**File No.:** DRV19-00306

**Subject:** **KIRKLAND URBAN SOUTH (PHASE 2) PROJECT  
DESIGN RESPONSE CONFERENCE**

# Kirkland Urban South

DESIGN RESPONSE CONFERENCE #2:  
8/19/2019

### Option 6 - Preferred Option

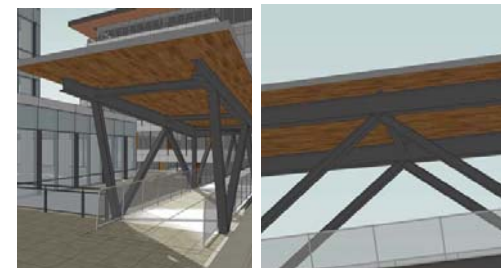
- Pedestrian Bridge.

The applicant should develop a more interesting "signature" design.

Option 6 is similar in overall form to option5 , but incorporates a more efficient truss configuration, and straight truss sections.

Pros: Interesting roof form that ties into phase one. Efficient structure with slender truss elements.

Cons: Somewhat difficult to drain.

### SUMMER SOLSTICE - JUNE 21

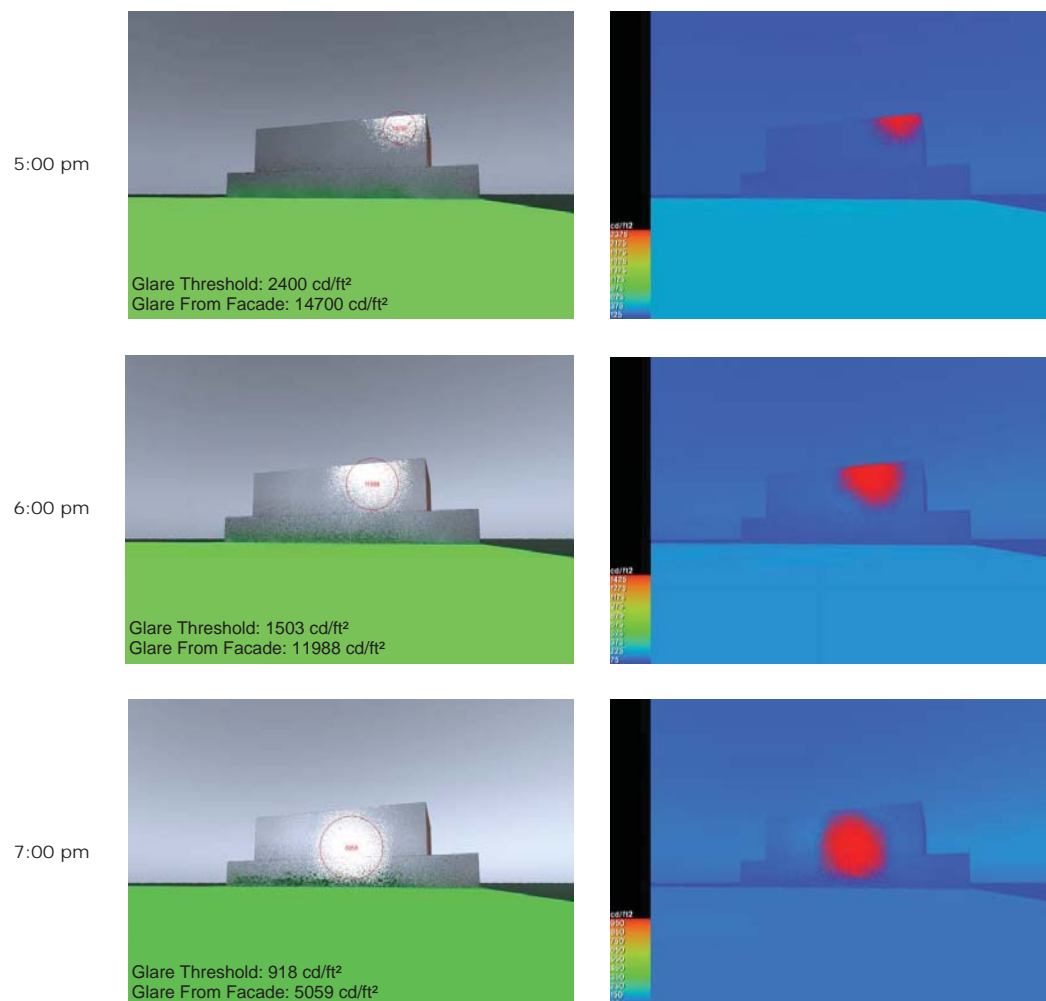
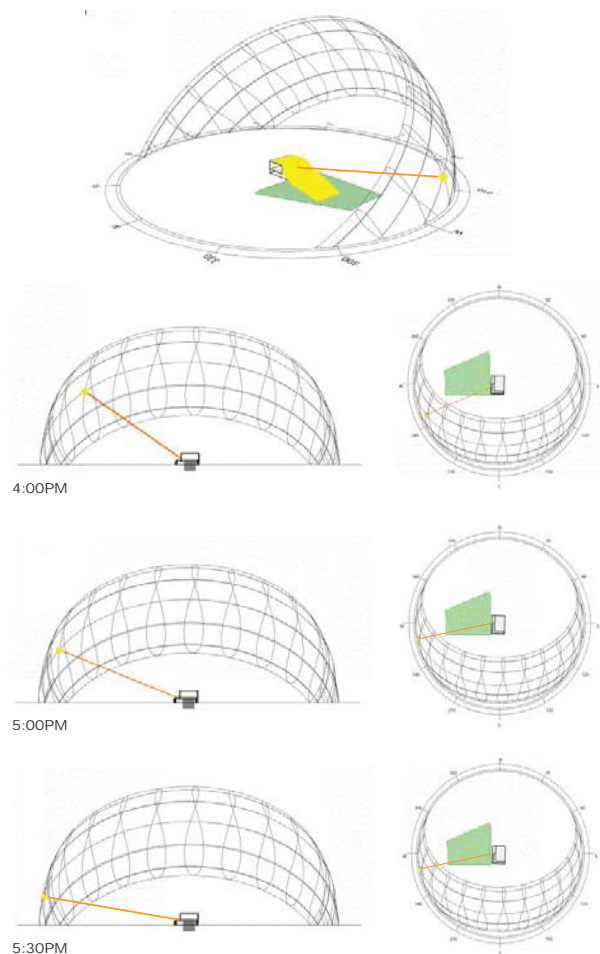
- Glare Study.

During the CDC conference the Board expressed concern with glare from the project impacting the park. A glare study was requested.

Reflected sunlight from the facade exceeds the glare threshold between 5pm and 8pm.

Note that the model does not take into account the amount of solid wall and the shading effect of vegetation, including both deciduous and evergreen trees and shrubs.
